City Environmental Quality Review

Environmental Assessment Statement

CEQR# 23DEP032M

**New York City Health and Hospitals
Corporation – Bellevue Hospital**

Figure 1. NYC HHC Bellevue Hospital Property Boundary

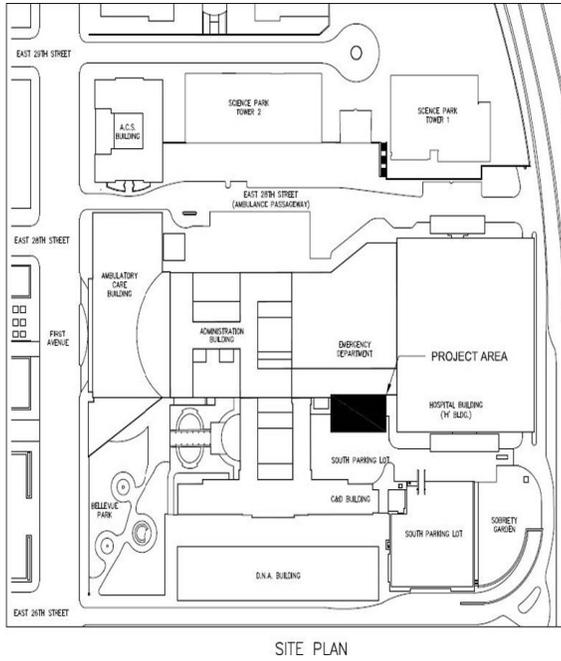
Commented [KT10]: The phrase "... provide continuous power and heat to the hospital in the event of an outage is confusing". For instance, elsewhere it is mentioned that the CHP system will operate on 24x7x365 days. Therefore, "... in the event of an outage" is self contradicting and confusing.

Commented [TC11R10]: Updated language to clarify

Figure 7: Future Floodplain 2100 (1% & 0.2% Annual Chance Floodplain)

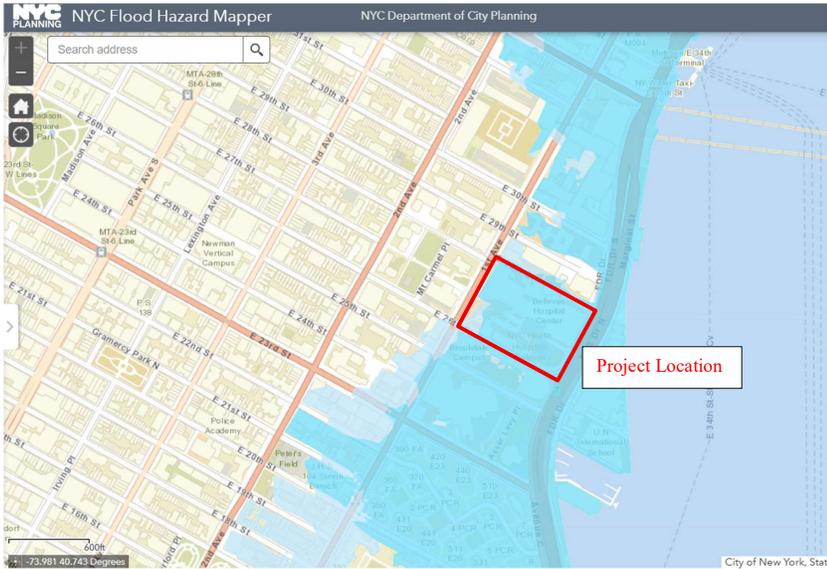
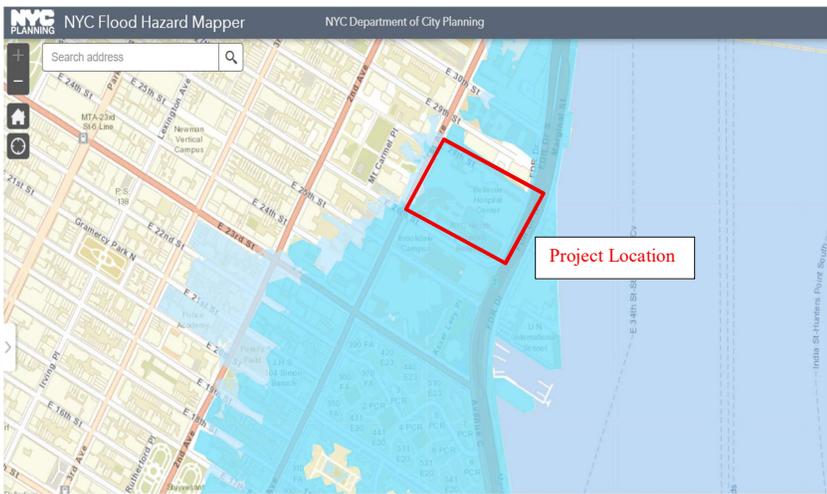
Commented [KT36]: What is the top rectangle above the project location rectangle?

Label it or delete it if it does not add value to the figure
